RESPONSE TO DEFERRAL - BRONTE SURF LIFE SAVING CLUB - DA-455/2022 - PPSSEC-239

Urbis has prepared this submission on behalf of Waverley Council (**the applicant**) with regard to DA-455/2022 (**the DA**) which was granted deferred commencement consent by the Sydney Eastern City Planning Panel (**SECPP**) on 5 February 2024 (PPSSEC-239). The deferred commencement consent approved the demolition of the existing Bronte Surf Life Saving Club (**SLSC**) and the construction of a new BSLSC including upgrades to the seawall and pathway access.

1. REVISED COASTAL RISK ASSESSMENT

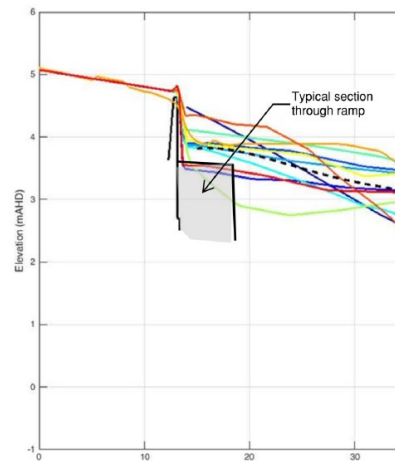
Resilience and Hazards SEPP	Assessment
(i) unreasonably limit or be likely to unreasonably limit public access to or the use of a beach or headland, or	The proposal would facilitate and enhance public and lifesaving access between the beach and the SLSC area and promenade, by providing a new ramp, steps, and bleachers. The new seawall and beach access facilities protrude up to 10.4m onto the beach from the face of the existing seawall, extending over a shoreline distance of 59m (average protrusion assessed to be 5.2m for a typical present-day accreted back-beach level of RL3.7m AHD). The reduction in sandy beach width as a result of these works can be assessed with reference to the SBEACH modelling undertaken by Baird, shown in the figures below. These capture the nominal beach state today (2016), and in 2050 and 2100, before and following a 100 year ARI storm. The local reduction in sandy beach width as a result of the seawall and associated beach access structures is up to 10% today (2016), increasing to 14% in 2050 and 33% in 2100. For a normal beach state not affected by storms, high tide beach width in 2050 would reduce from 45m to 38m, and in 2100 from 24m to 17m. These changes, which occur locally in front of the proposed SLSC seawall, the overall length of which is approximately 25% of the length of the beach, are considered acceptable given the public and lifesaving benefits that the works provide. While the width at other areas along Bronte Beach would remain unchanged, it is acknowledged that not all the beach is used to the same degree with user density greatest where the flags are typically placed. With respect to the suitability of the design for beach access over the life of the works, beach recovery following the severe storms would be initially relatively rapid and expected to mostly occur over a period of days to weeks. Immediately following these storms, Council may need to assist in reinstating the eroded beach at the base of the ramp and steps, scraping sand up to the proposed design toe level of 3m AHD. Refer to the BOMP at Appendix C which outlines Council's approach to managing beach erosion. The proposed access to and from the beach is a substantial improvement over the existing situation. It is considered that the works would not, over the life of the works, unreasonably limit public access to or the use of the beach. Sectional profiles developed from photogrammetry and SBEACH modelling, overlaid on a typical section through the new ramp, are shown below:

Typical section through the ramp shown to be mostly covered with sand, based on beach profiles between 1970 and 2016. (Section L01 from Baird 2016, 20m south of centre of SLSC buildings Coloured profiles show photogrammetric surveys of the beach between 1970 and 2016 with a black dash representing an average profile). Note that the ramp section here is simply overlaid onto the surveyed profiles. The influence of the ramp would have been minor on the profiles as surveyed.

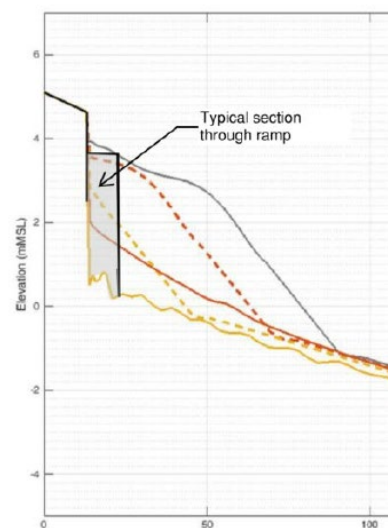
Typical section through the middle portion of the ramp over the life of the works, showing the nominal existing (2016) average beach profile (grey), and model predicted profiles in 2050 and 2100 before (brown dash and yellow dash respectively) and following a 100-year ARI storm (brown full and yellow full respectively). (Section L00 from Baird 2016, 15m north of centre of SLSC buildings). Note that the ramp section here is simply

overlaid onto the modelled profiles and is not included in the modelling. The influence of the ramp would result in the modelled profiles being slightly lower than those shown, particularly for the 2050 post-storm profile (brown full), and the 2100 pre-storm profile (yellow dash). Assuming a mass balance across the section, the adjustment would be expected to entail a lowering of up to 0.5m across the subaerial profile, from the face of the ramp out to the mid-tide waterline.

Figure 1 Physical Modelling of Seawall – Indicative Timeframe

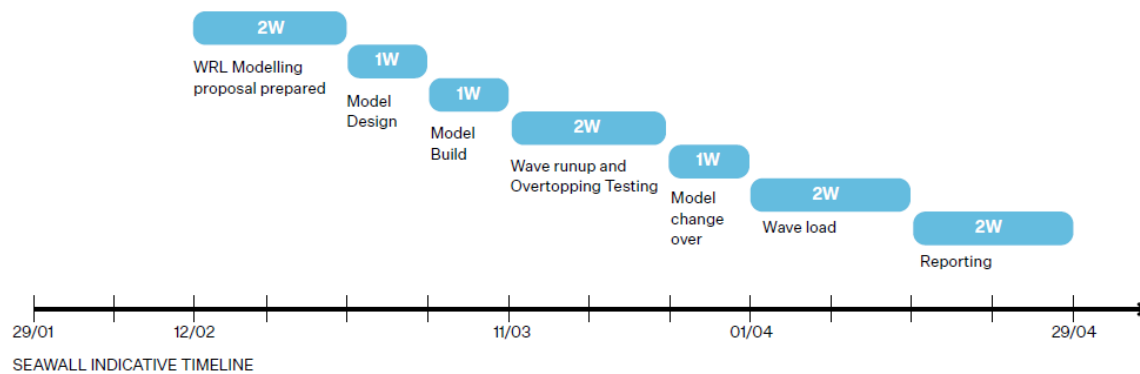
Physical modelling is proposed in the next phase of the seawall design, to provide further information for seawall design development. The physical modelling is proposed to enhance the quantification of wave overtopping flows, assess hydraulic loads, potential damage, and user safety. The work would involve 2D modelling, incorporating coastal profiles and boundary conditions developed for Bronte.

It is expected physical modelling would be a condition of development consent, to be undertaken to inform the detailed design. The indicative timeframe for seawall modelling is provided at **Figure 1**. The physical modelling will be undertaken by the UNSW Water Research Laboratory (WRL). The contract is currently being reviewed by WRL and following signature, the modelling will commence immediately. Useable data to inform seawall wave deflector design will be available in March and the final report will be completed in April.

On this basis, it is requested the Deferred Commencement Condition 1 be deleted and instead tied to a condition of consent which requires a Stage 2 Detailed Seawall Design and wave return walls, including all required physical modelling to be undertaken and findings submitted to Council for prior to the issue of the relevant construction certificate (i.e. prior to the main building works). Additionally, a minor amendment to Condition 3 is requested to allow for site preparation works to occur prior to satisfaction of the seawall design condition listed below.

A Stage 2 Detailed Seawall Design and wave return walls, including all required physical modelling to be undertaken and findings submitted to Council for approval of Council's Executive Manager, Development Assessment or delegate prior to the issue of the relevant construction certificate for the main building works.

Figure 2 Indicative Temporary Facilities Layout

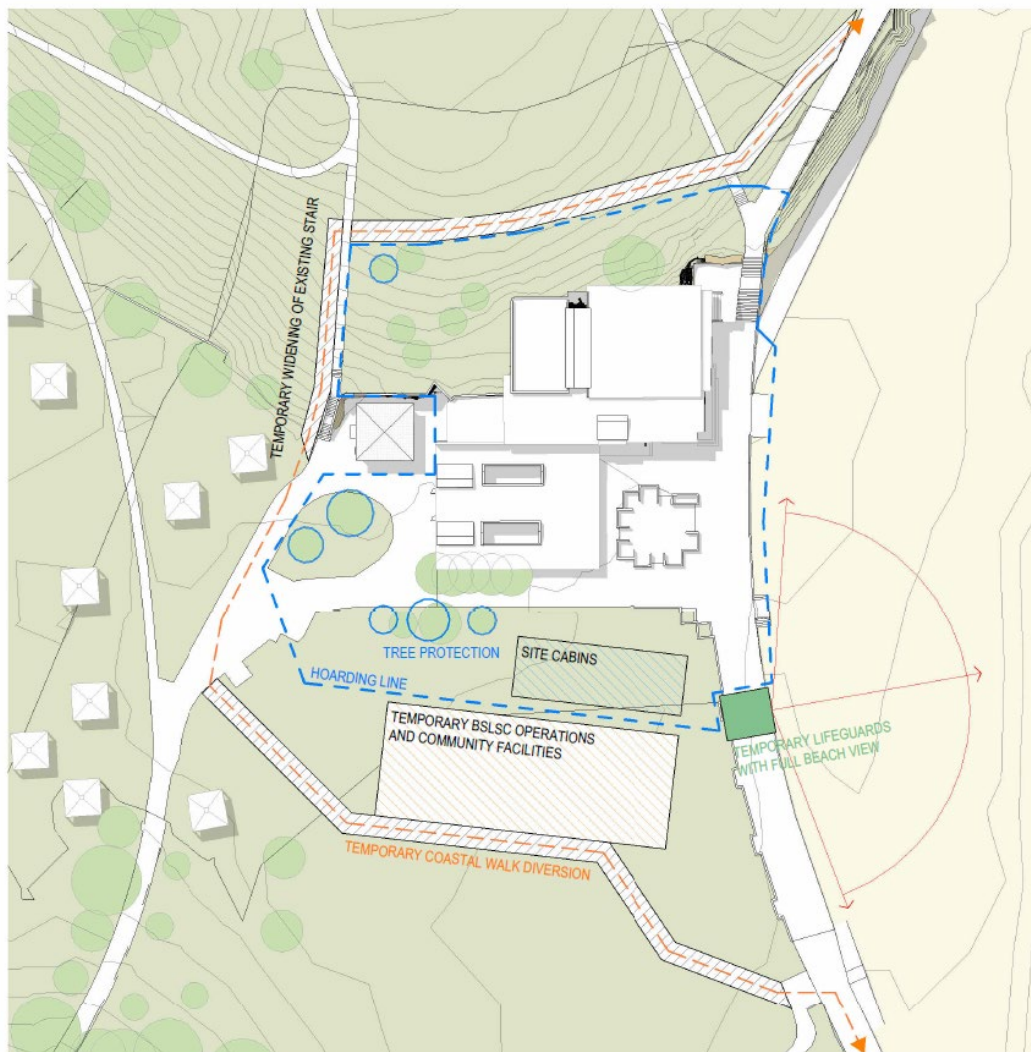
As documented in the Construction Management Plan (dated 21 September 2022) submitted with the original DA documentation in October 2022, it is intended that temporary facilities will be constructed adjacent to the Southern portion of the site in Bronte Park in order to commence demolition of the existing SLSC building. These facilities will be designed to ensure that the critical functions of the Lifeguards and the SLSC are maintained through the construction process. In order to undertake

these works, the site will be enclosed with perimeter A Class fencing and all materials will be delivered to the site from the Bronte Rd accessway, under suitable traffic escort. **Figure 2** below shows the indicative temporary facilities layout.

We would like to request the insertion of a condition that reflects the intended provision of temporary facilities for the continued operation of the SLSC.

Prior to commencement of works, a Construction Management Plan needs to be prepared and submitted to Council for approval. The Construction Management Plan should provide building and operational details of the temporary facilities intended to be used for surf lifesaving operations during the construction of the Bronte Surf Life Saving Club.
